# PREVOST

## WARRANTY BULLETIN

**WB23-23**

DATE :	August 2023	SECTION :	04 EXHAUST
EXPIRATION:	August 2025		
SUBJECT :	<b>EXHAUST LEAK</b>

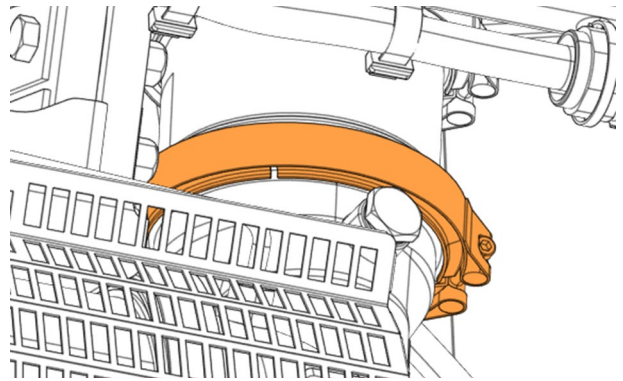
3. Check if you see exhaust leak see picture.  
If yes go to next step.  
If not, reattach the blanket to complete the procedure.

4. Remove the clamp and gasket

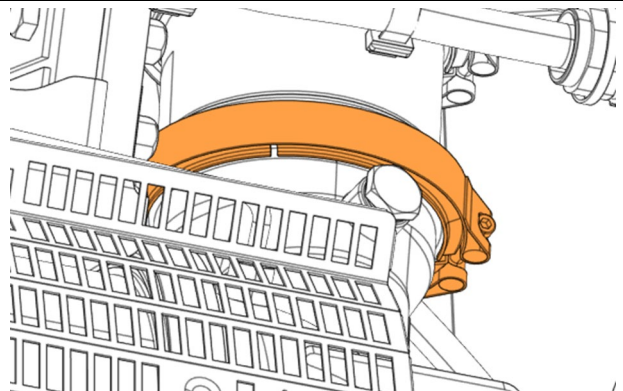
5. Grind off welding spatter of the DPF output.

6. Install the new gasket 21095726.
7. Reinstall the clamp with a torque of 100 lb-in.
8. Reattach the blanket.

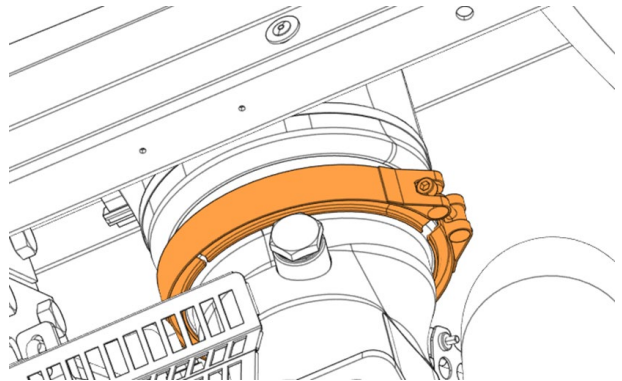
2. Check if you see exhaust leak see picture.  
If yes go to next step.  
Otherwise, the procedure is complete.

3. Remove the clamp.

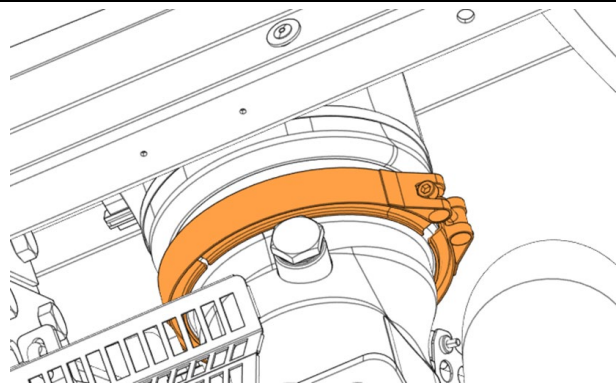
9. Grind off welding spatter of the DPF output.

4. Install the new gasket 21095726.
5. Reinstall the clamp with a torque of 100 lb-in.
6. Reattach the blanket.
